VILLAGE OF TUSCARAWAS
TUSCARAWAS COUNTY, OHIO

CHERRY ST WATER LINE REPLACEMENT & STORM SEWER IMPROVEMENTS

ADDENDUM #1

THRASHER PROJECT #T10-11077

SHEET No.
D1

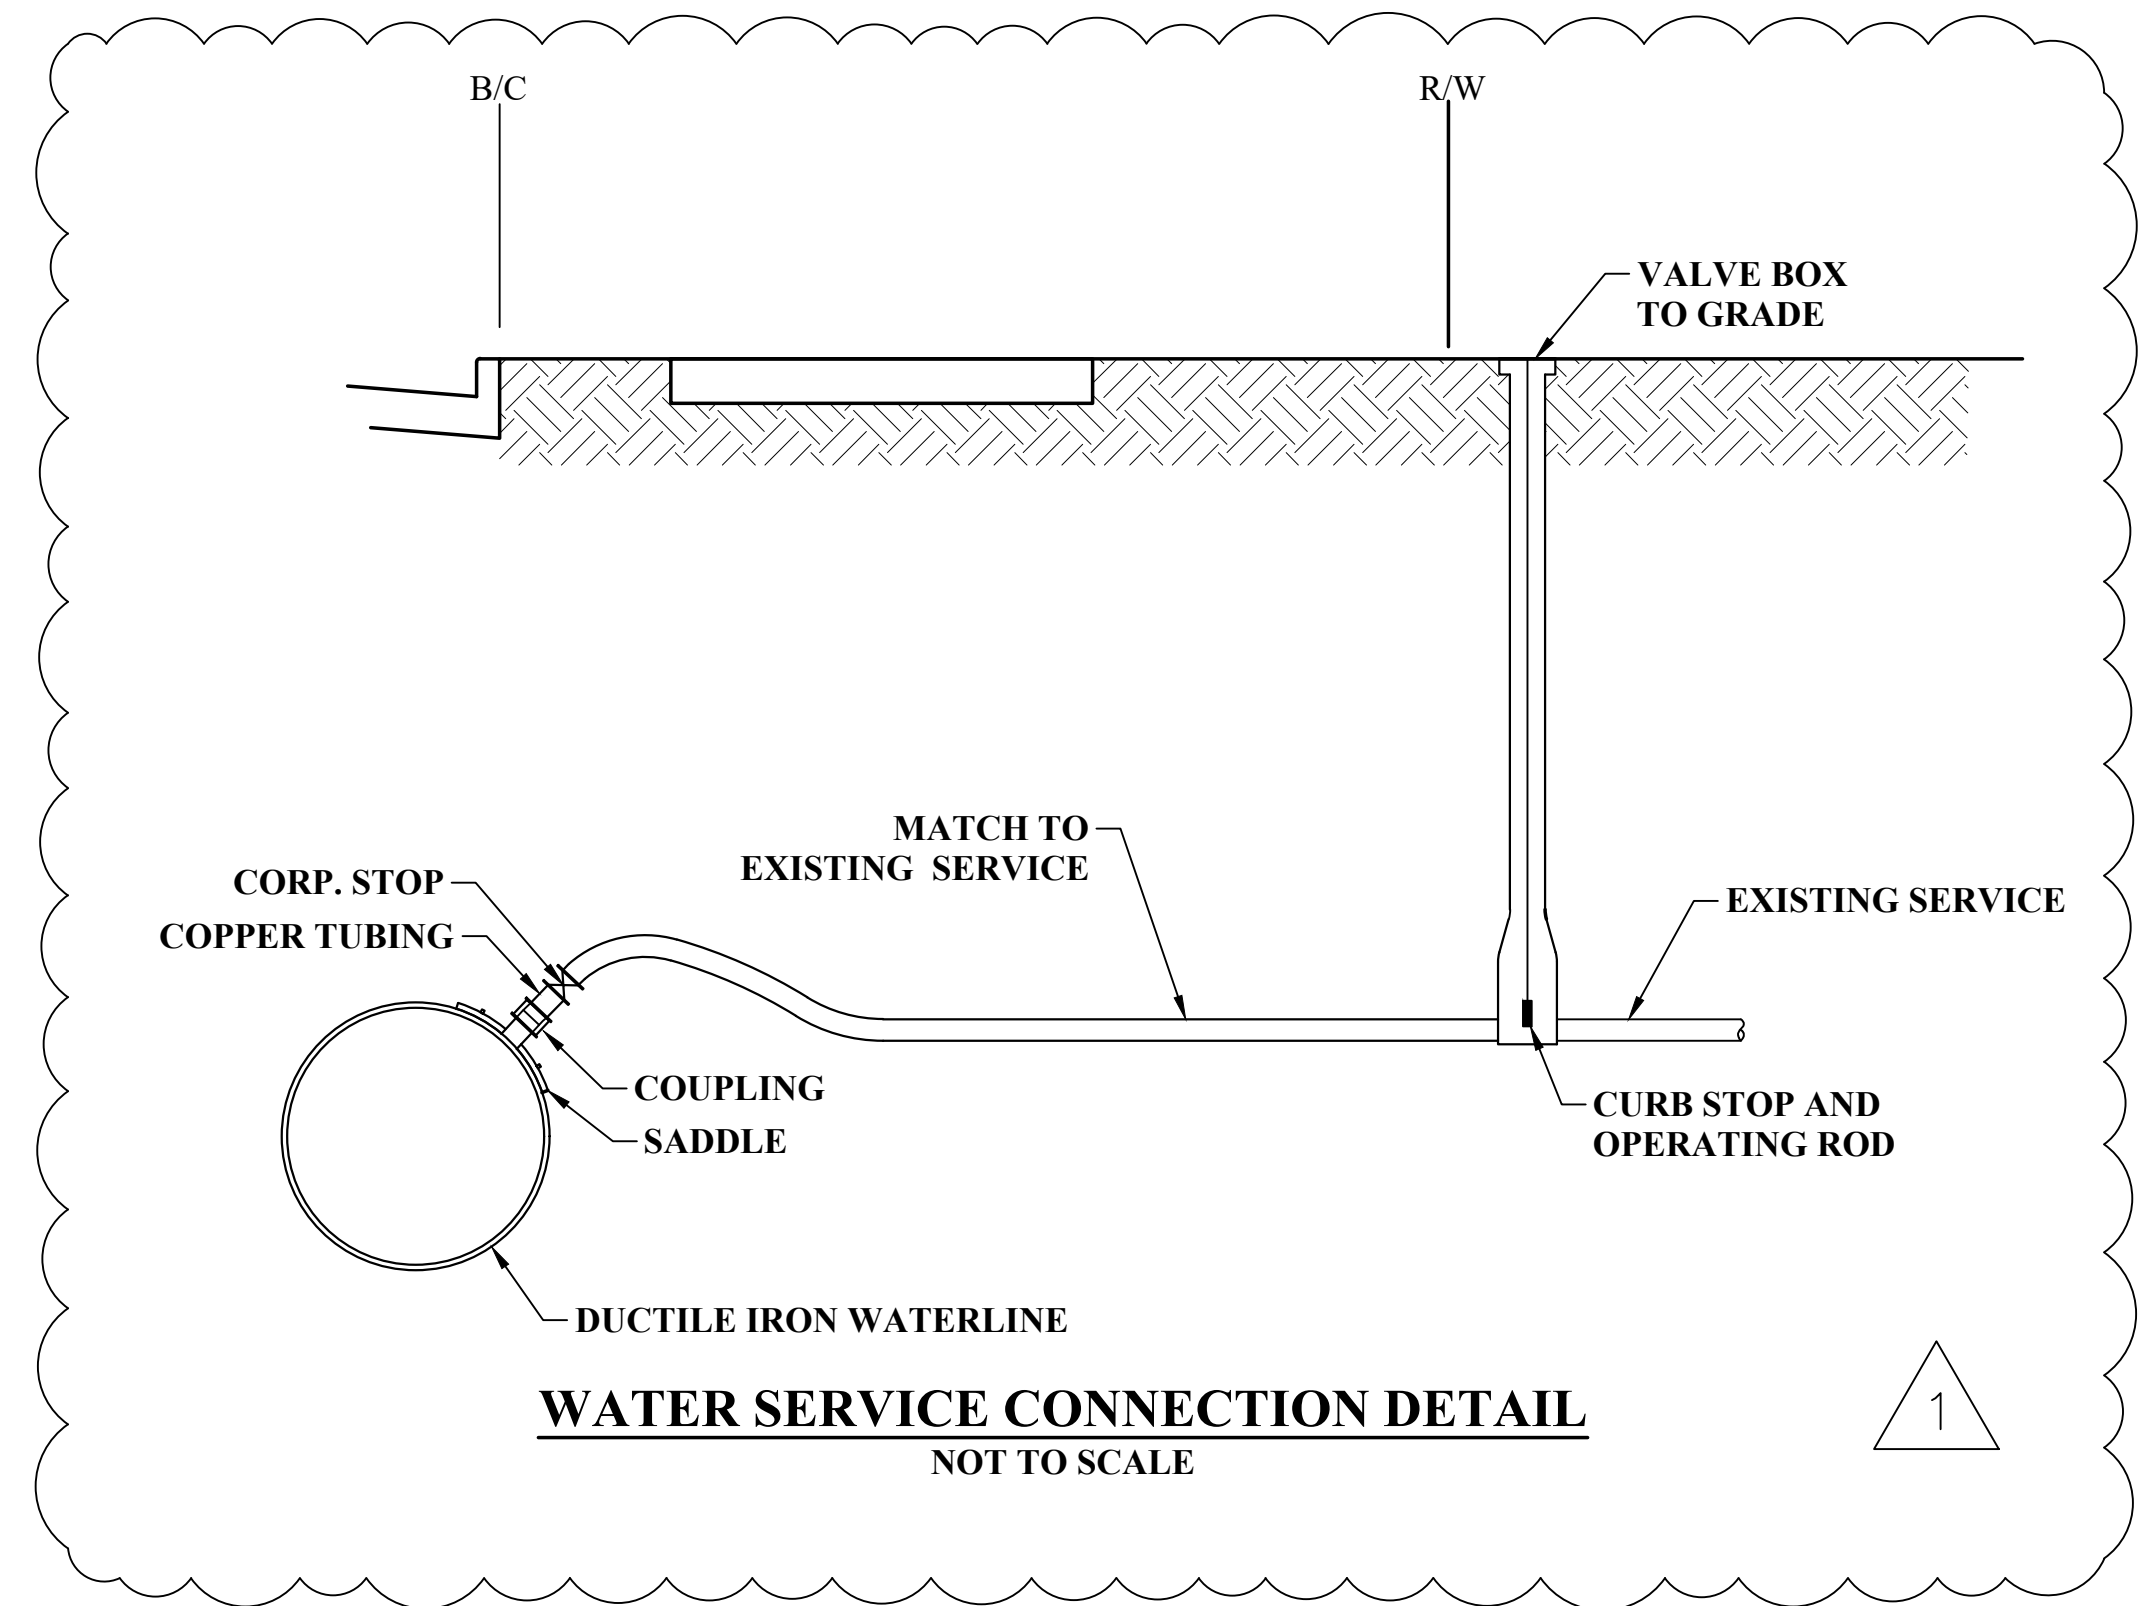
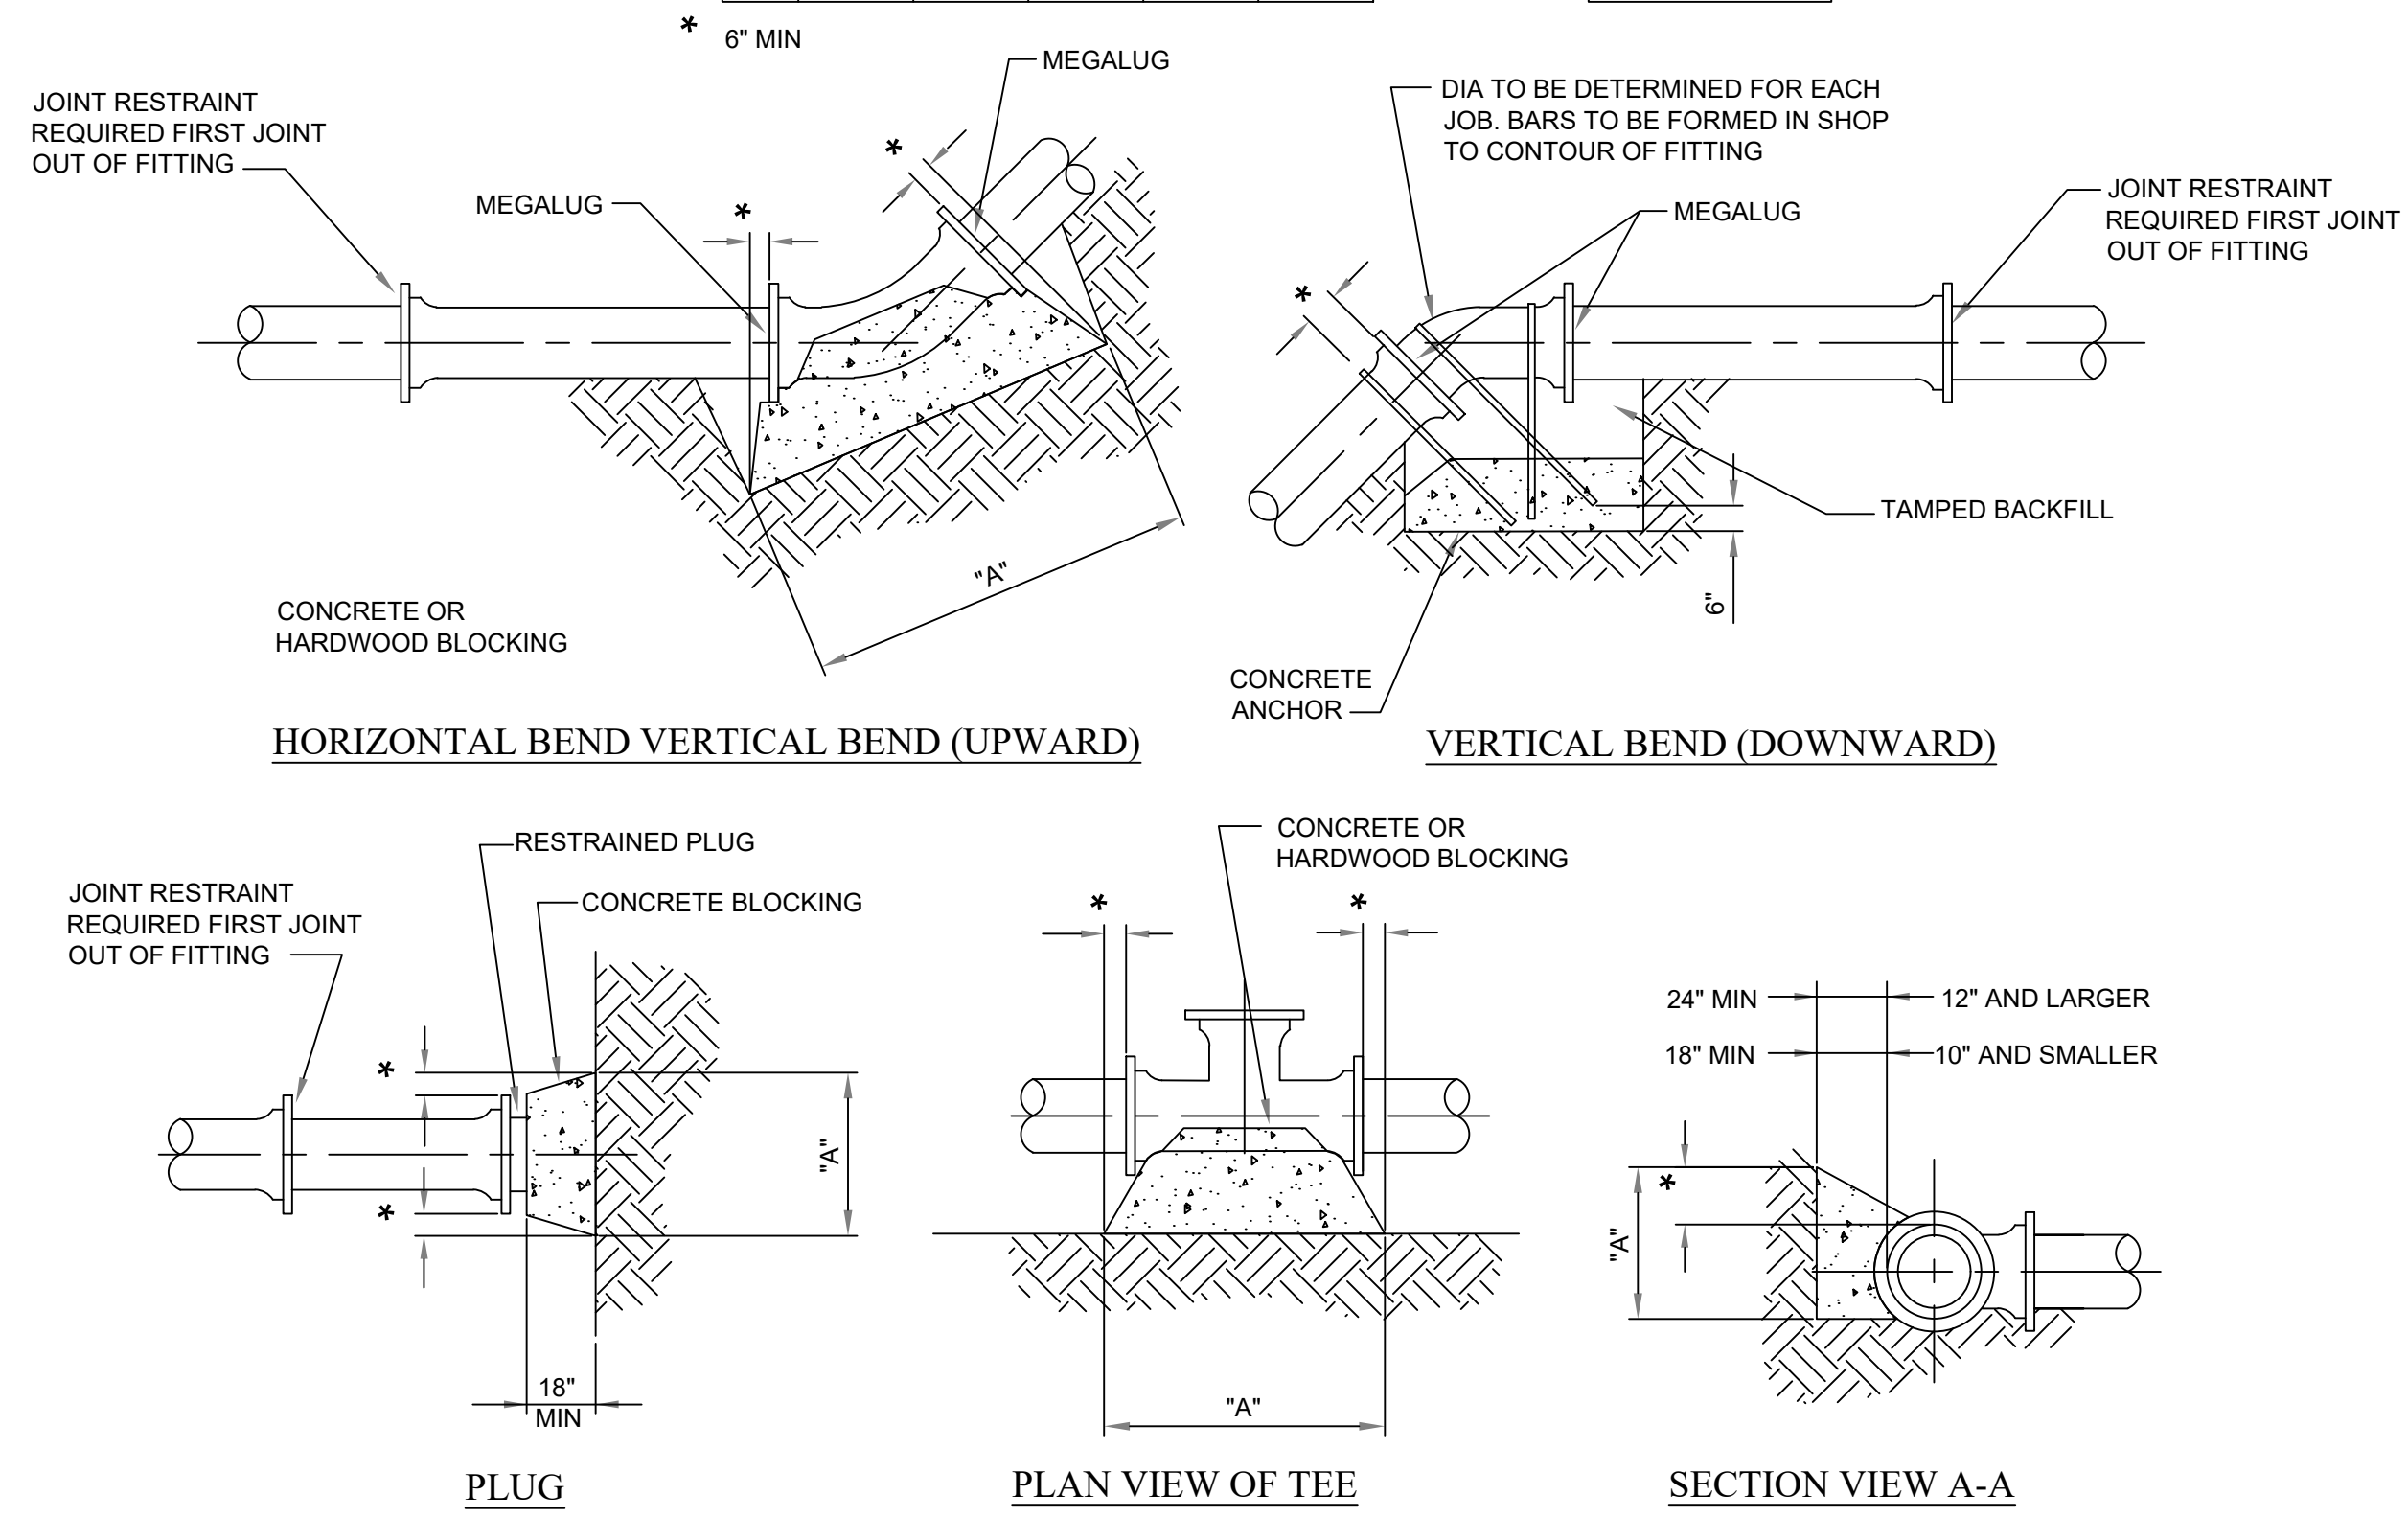
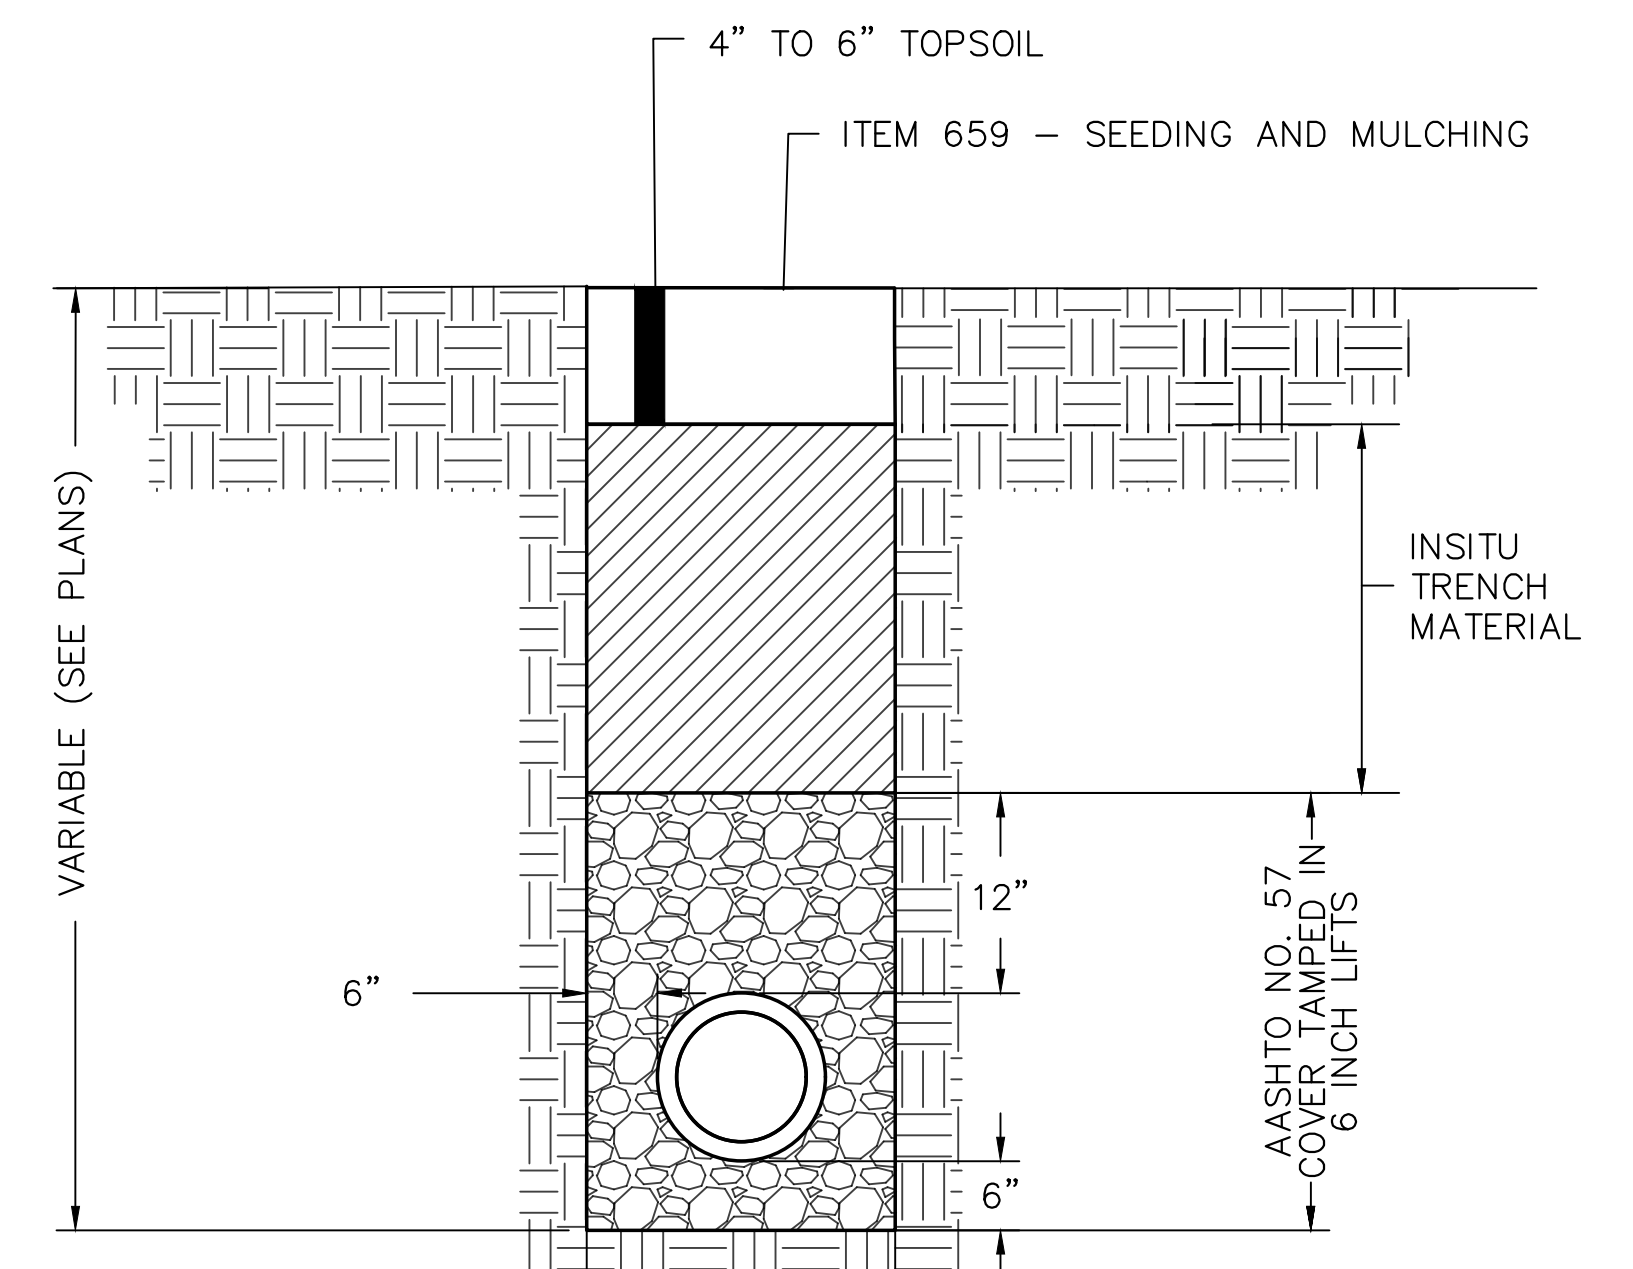
12. QUESTION

On page D1 for water service is a saddle to be used for water service or direct tap on
ductile? The drawing has an electrofusion saddle and coupling which ductile iron pipe
is to be installed.

RESPONSE

See revised detail Sheet D1.
